**THE CITY OF THE VILLAGE OF DOUGLAS
PLANNING COMMISSION
THURSDAY, AUGUST 13, 2026 AT 6:00 PM
415 WEST WILEY RD, SUITE 103, DOUGLAS, MI
49406**

To: City of the Village of Douglas Planning Commission
Date: August 3, 2026
From: Sean Homyen, Planning & Zoning Administrator
RE: 13 S Union St – Site Plan Amendment – Mix-Use Building

To: City of the Village of Douglas Planning Commission

RE: Douglas Mixed Use (225 Center Street) – Douglas
Engineering Review Comments

Sheet No. 0501

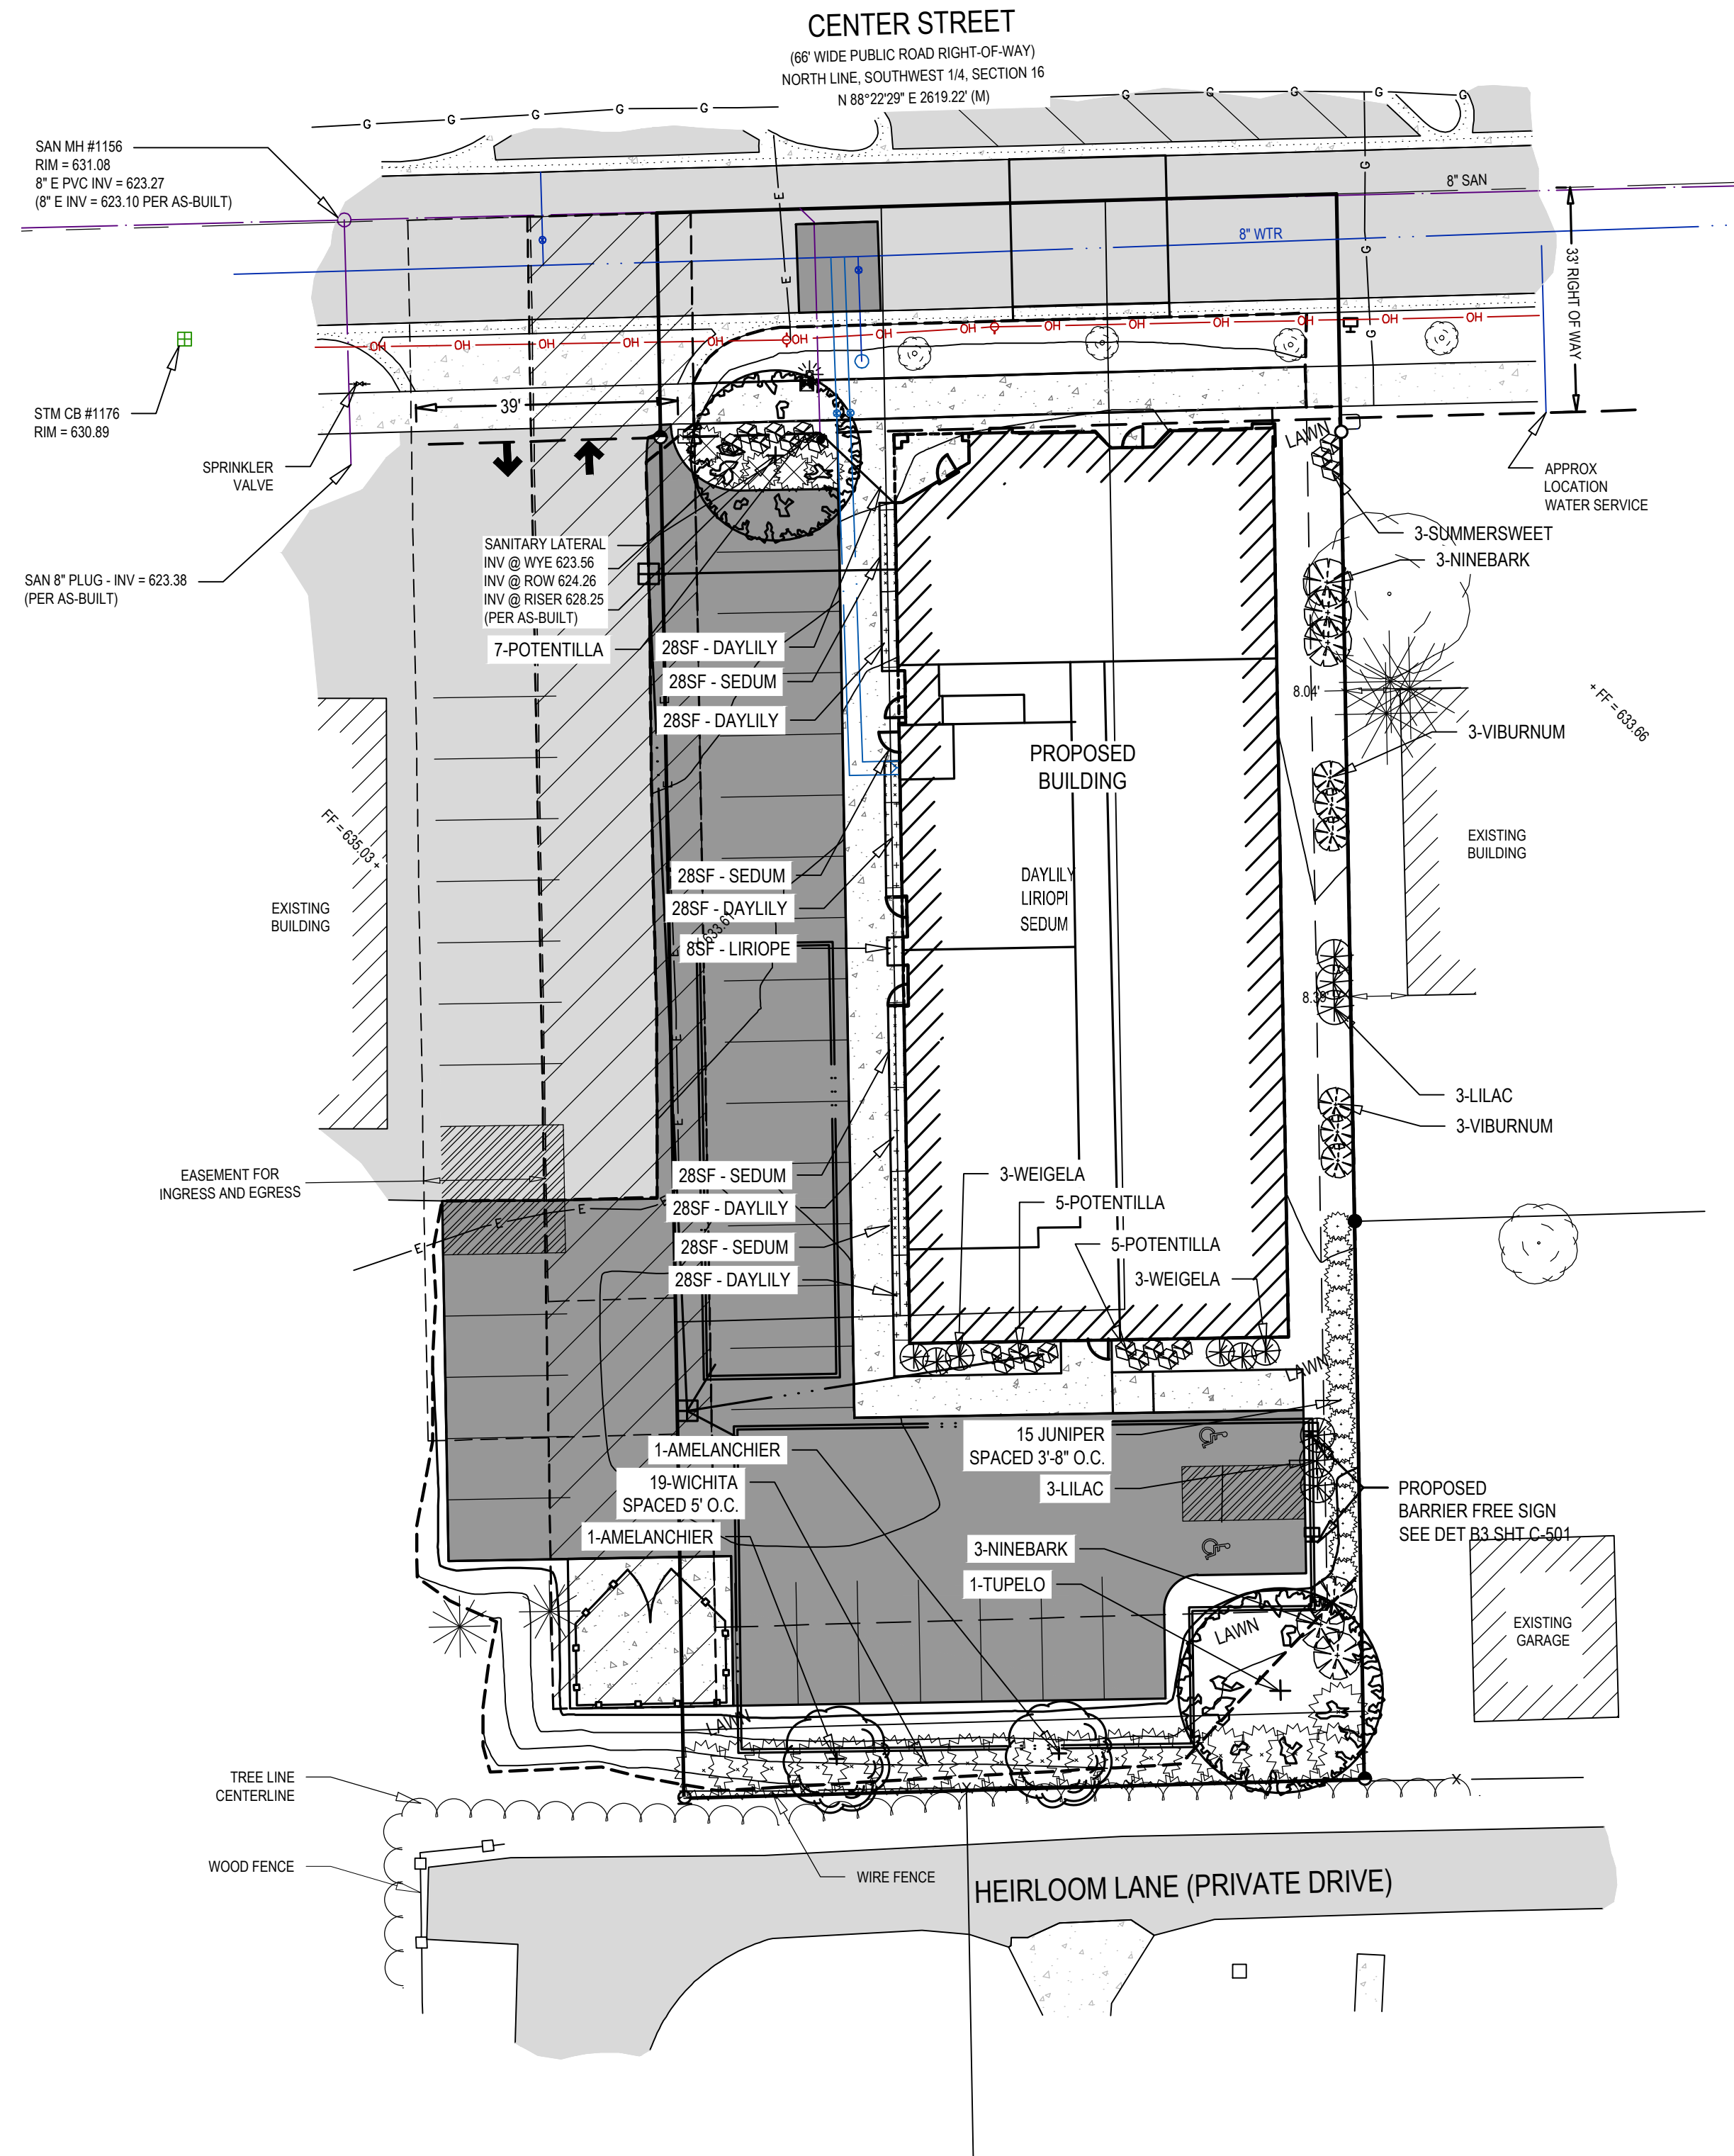
3. The following items are noted regarding the construction drawings:
 - a. Storm sewer within the public right-of-way must be concrete; please revise.
 - b. No openings are shown in the outlet detail on C-501, detail B1 that match the calculations.

225 West Center - Mixed Use
225 West Center Street
Douglas, MI 49406
First & Second Floor Plans

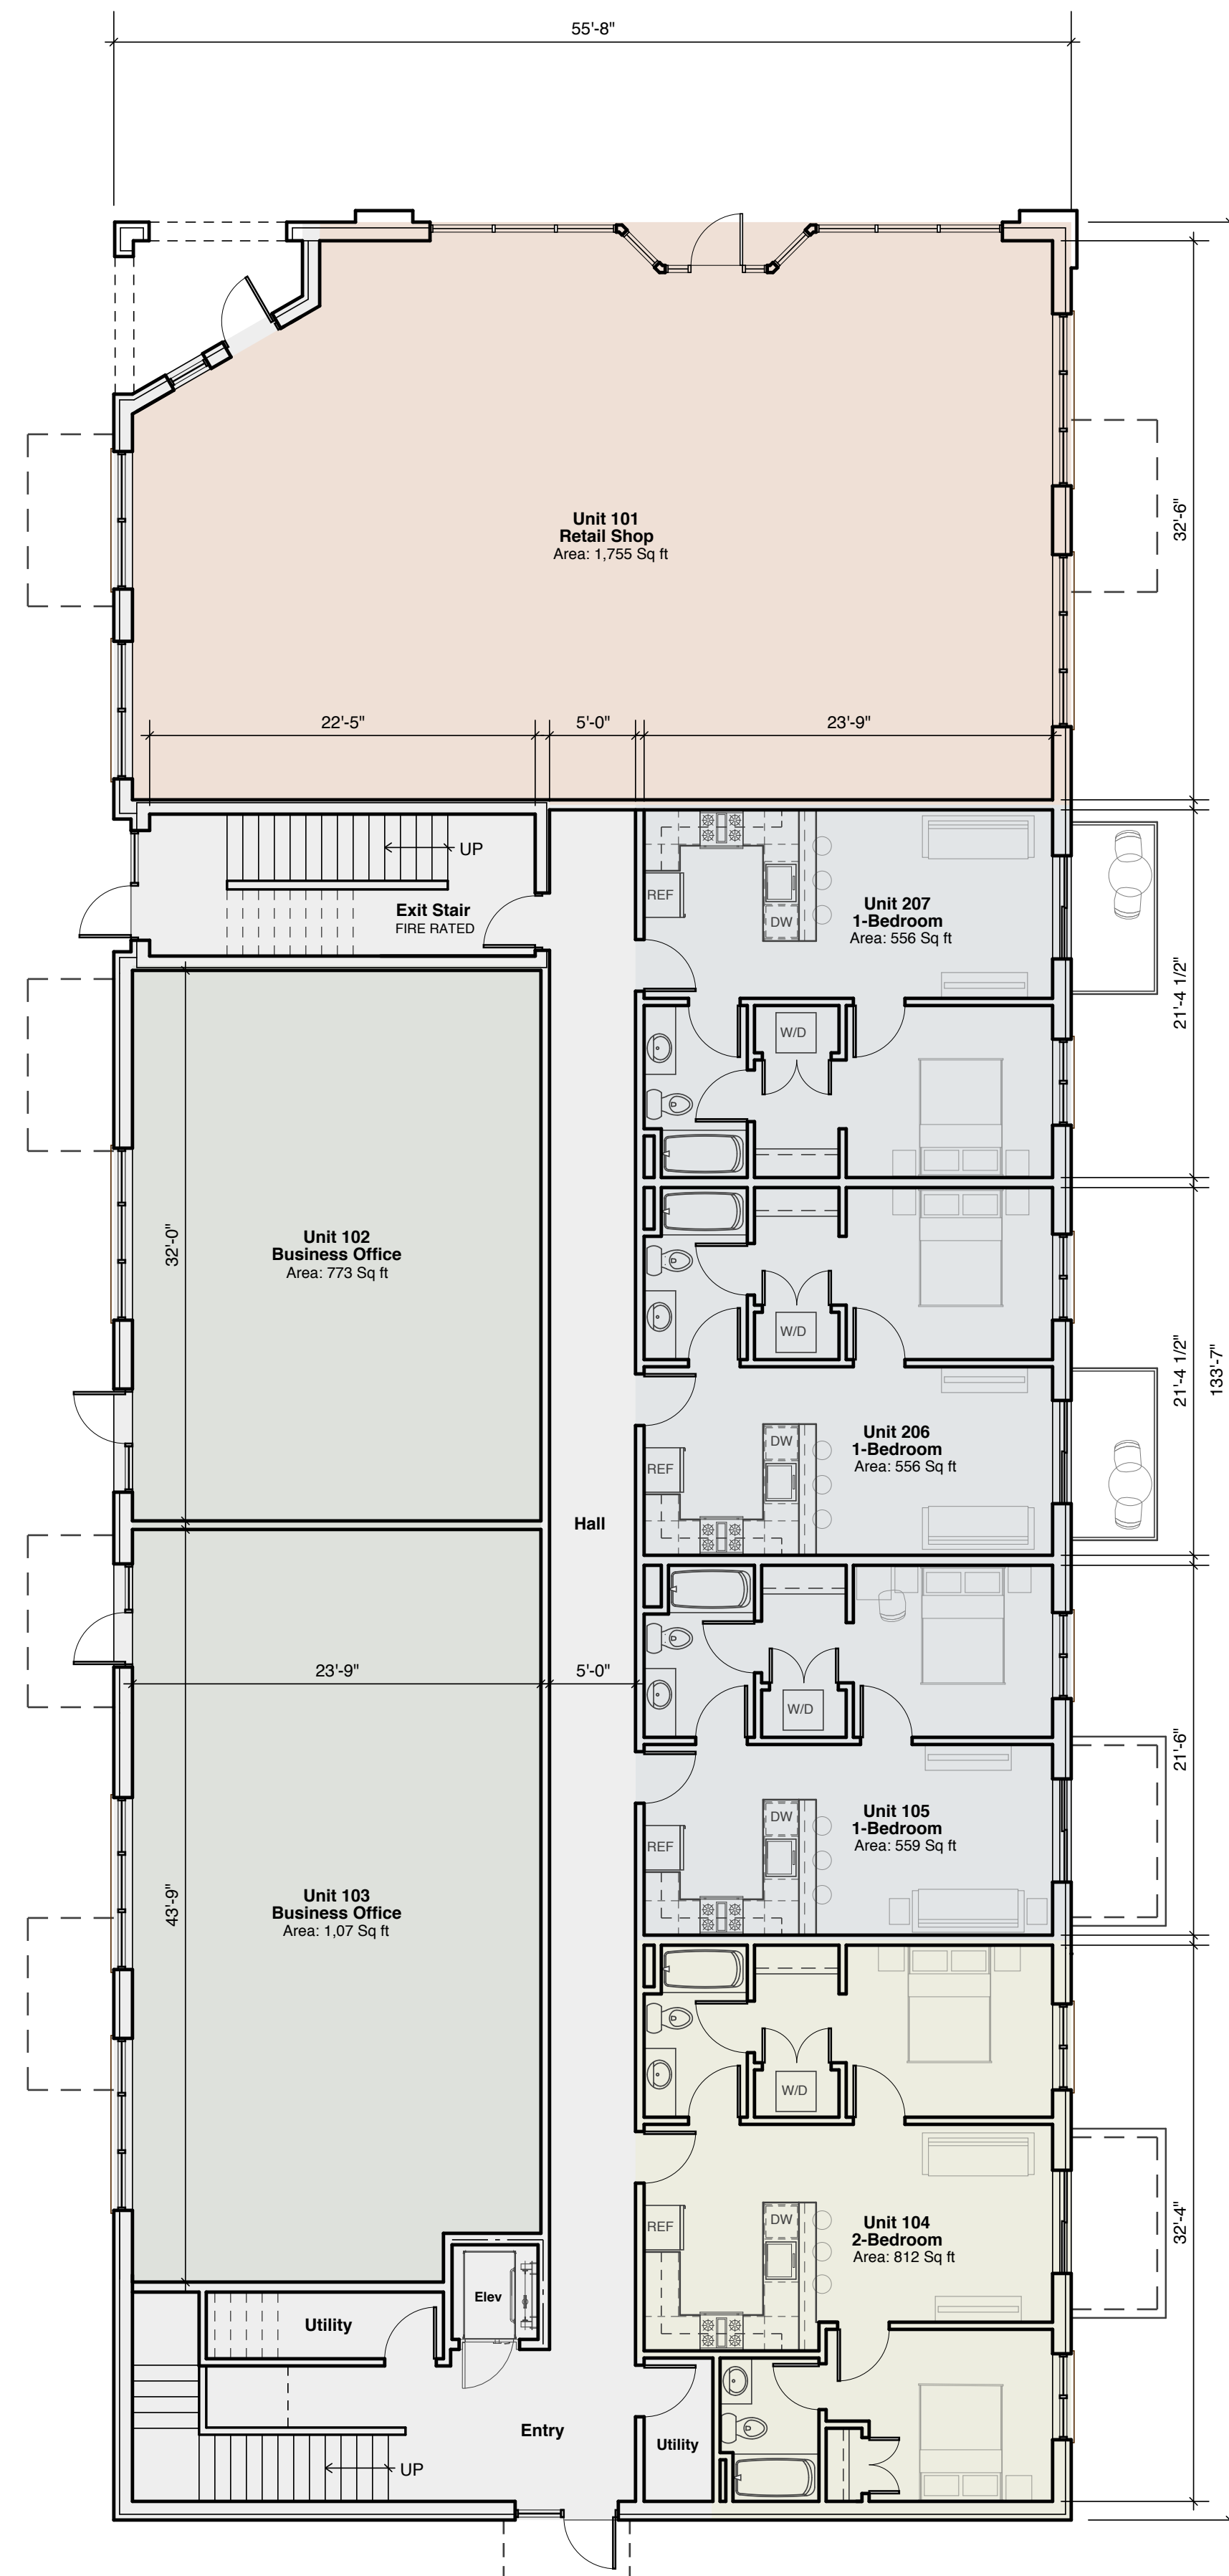
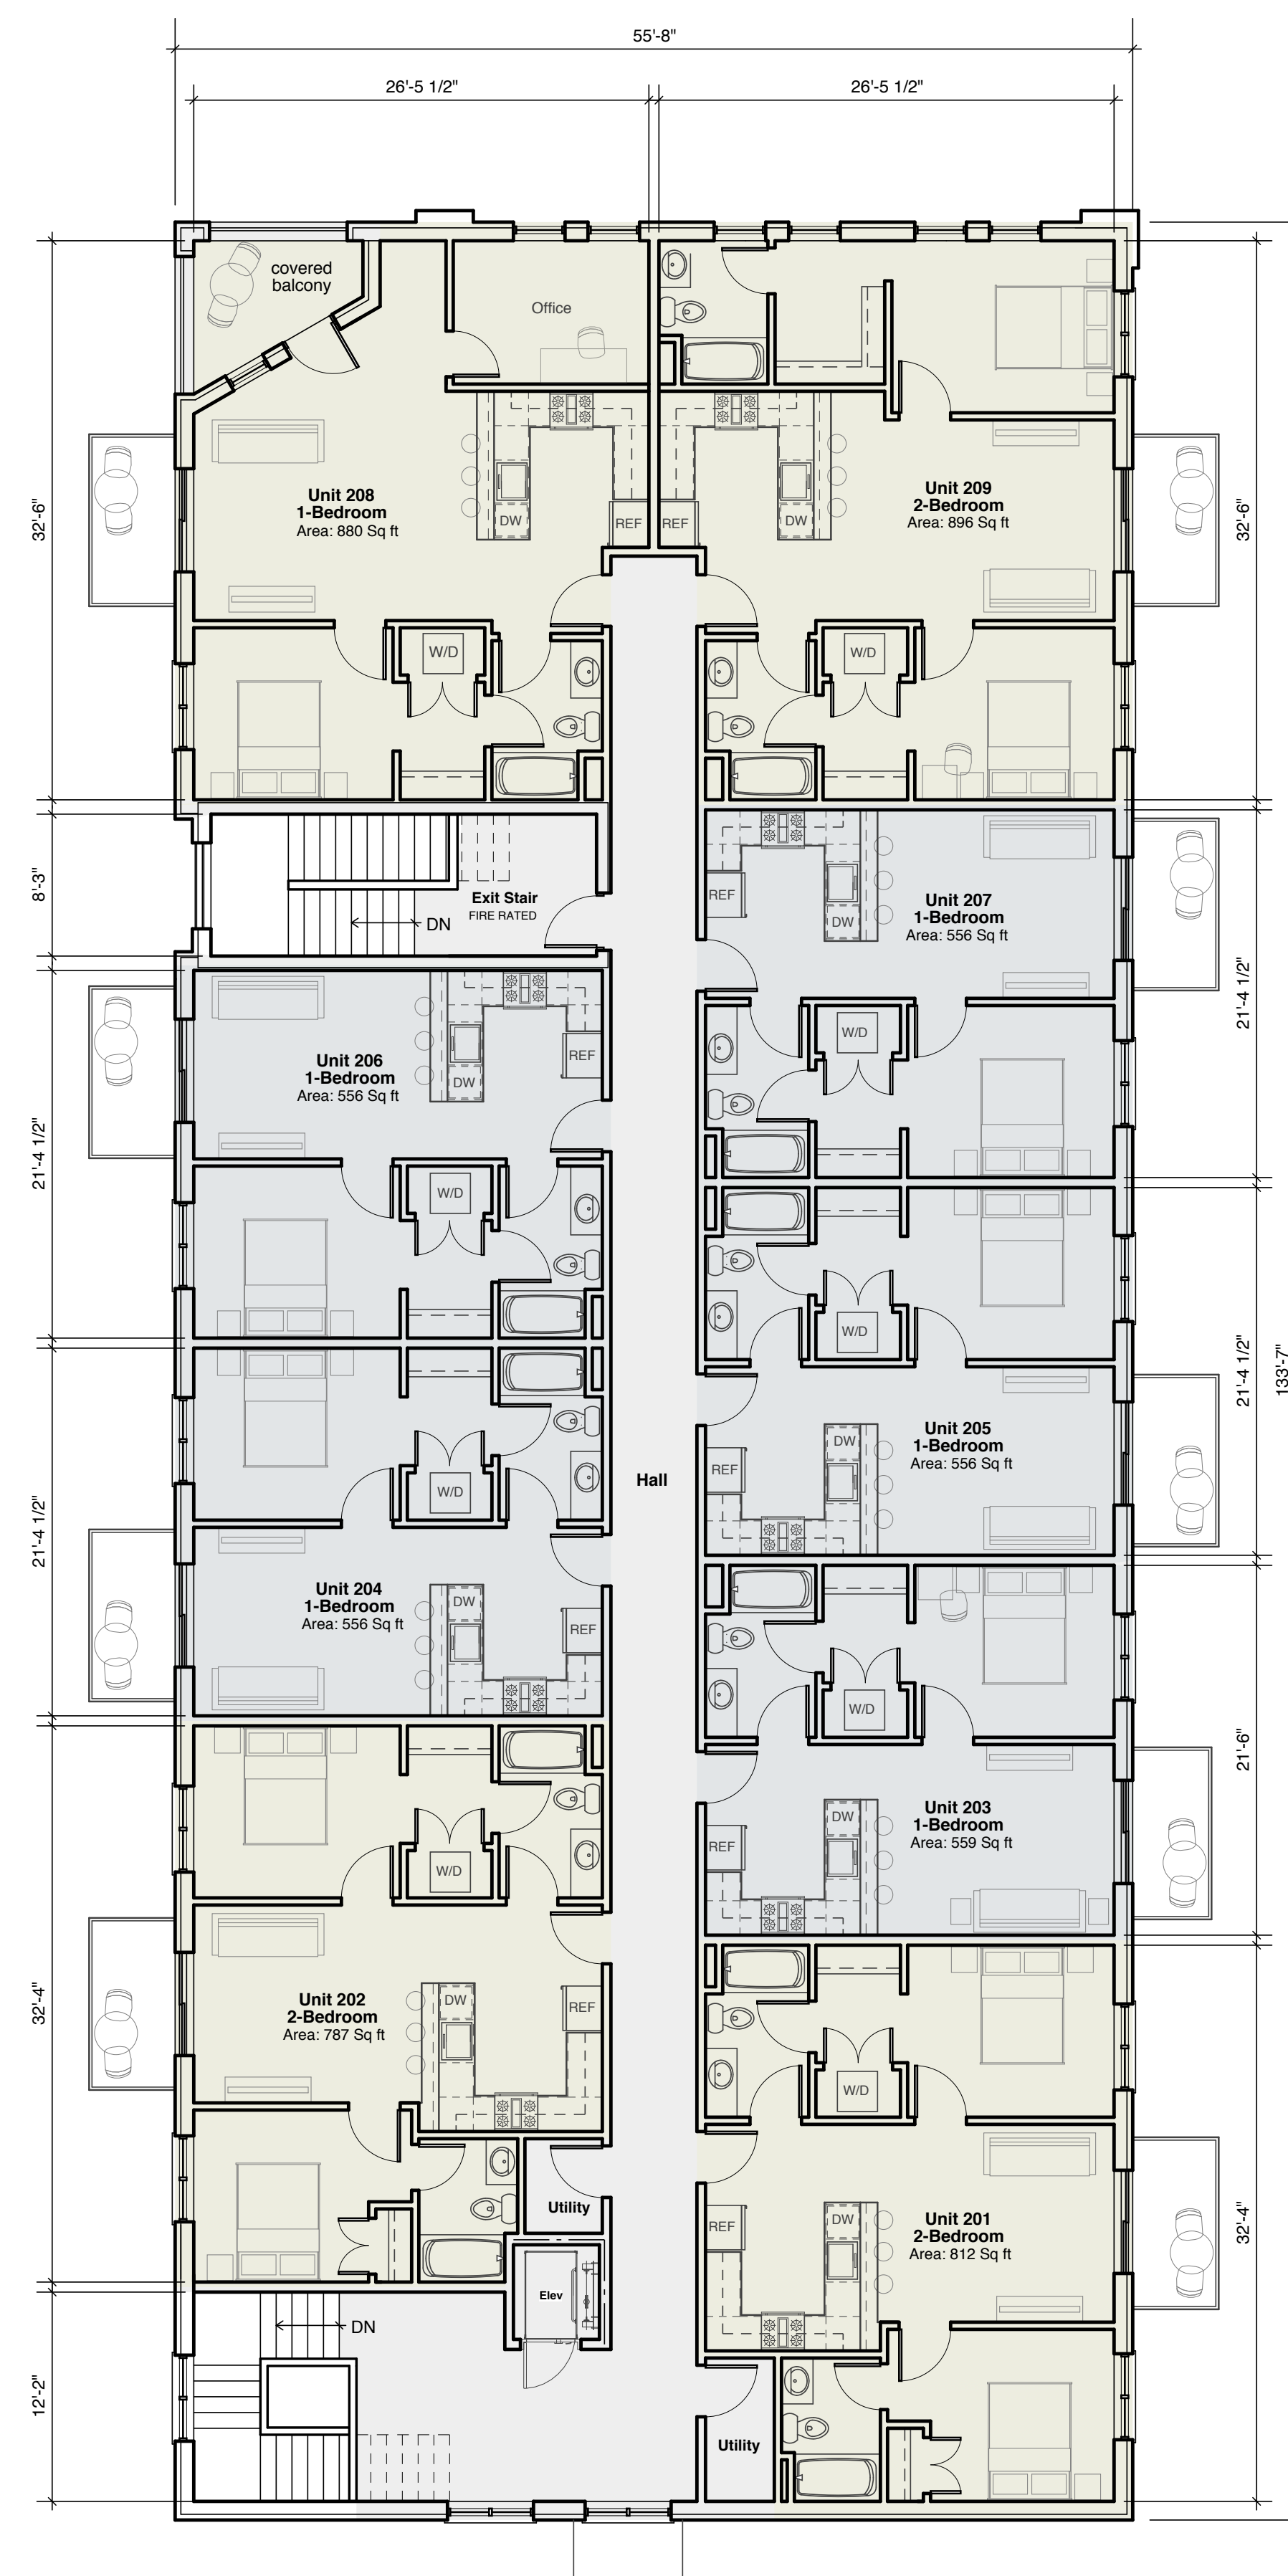
Remarks. The applicant should revise the floor plans to accurately reflect the number of dwelling units. The plans currently identify four (4) two-bedroom units; however, the proposed development includes three (3) two-bedroom units and six (6) one-bedroom units. In addition, the depth of the recessed entry is not identified on the plans. The applicant should provide this dimension to demonstrate compliance with the required three (3) to five (5) foot recessed entry standard.
